Administrative Approval Preliminary Site Plan

Case File / Name: SP-20-14 / Taverna Agora

Nature of Case: The renovation and 321 square foot expansion of an existing 4,920 square foot building including a 2,100 square foot rooftop terrace for a proposed restaurant. The subject property is .22 acres and zoned Business with Downtown Overlay District.

SP-20-14 / Taverna Agora – Site Plan

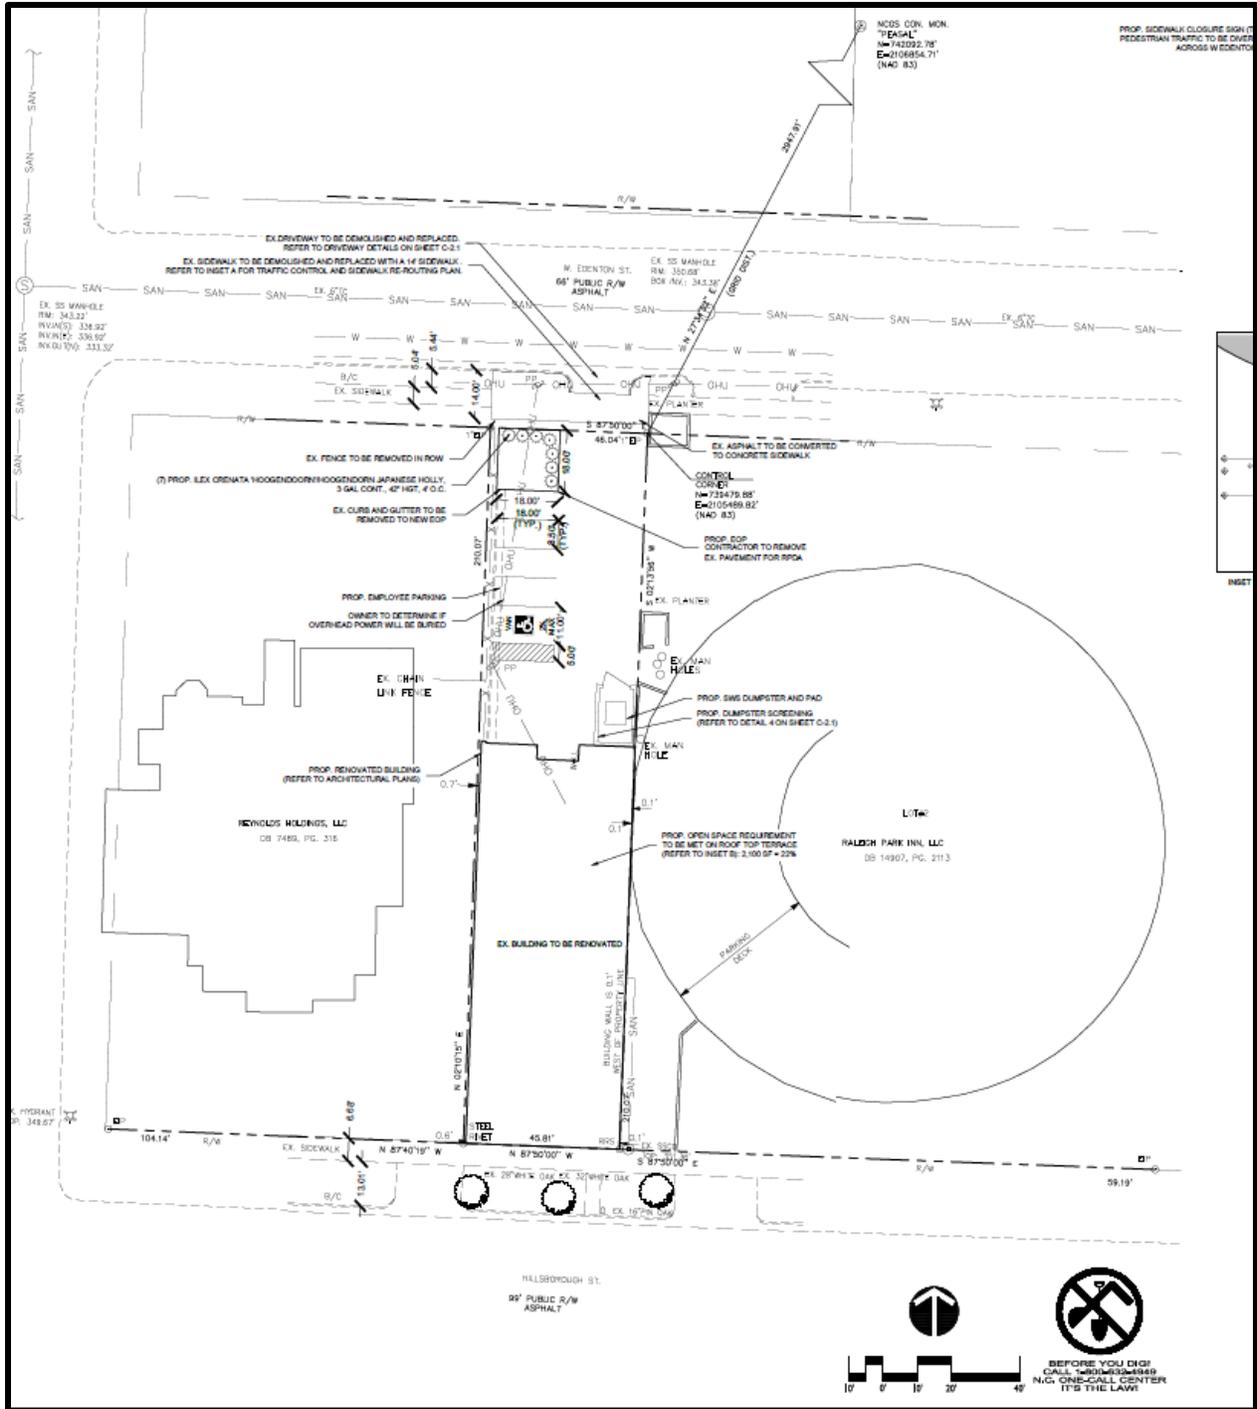
1. That an offer of cross access easement be made to the property to the east, DB 14907 page 2113, and be recorded with the Wake County Register of Deeds and a copy be provided to the City prior to building permit issuance;
2. That the final site plan shows a sidewalk construction detail plan for the 14' sidewalk along Edenton Street showing the required 2' paver band at the back of curb and 2'x2' capital grid concrete for the remainder of the width in accordance with Public Works Department standards;
3. That if the proposed public improvements are not installed and inspected by the city to be accepted for maintenance, a surety in the amount of 125% of the cost of construction for the 14' sidewalk installed on Edenton Street is to be paid to the Public Works Department in accordance with code section 8.1.3 of the UDO.
trees

STREETSCAPE TYPE: This development is subject to the Downtown Streetscape Master Plan. The proposal shows compliance with the standards of this plan by providing a 14' sidewalk along Edenton Street with a ramp-type driveway. A Design Adjustment has been granted by the Public Works Director to allow the existing streetscape on Hillsborough Street to be preserved with no additional improvements.

CIRCULATION: Proposed street improvements shall conform to normal City construction standards. A new ramp-type driveway will be constructed from Edenton Street to replace the existing drive. An offer of cross-access will be required to the property to the east, identified on DB 14907 page 2113.

PEDESTRIAN: Proposed sidewalk locations conform to City regulations. Sidewalks exist along both Hillsborough and Edenton Streets. The construction of a 14' sidewalk is required along Edenton Street and shown on the plans.

STORMWATER MANAGEMENT: This project is proposing no additional impervious surface and claiming exemption to active stormwater control requirements as afforded to them by UDO Section 9.2.2.A.4, Substitution of Impervious Surfaces. The plan shows an overall reduction of 64 square feet of impervious surface.
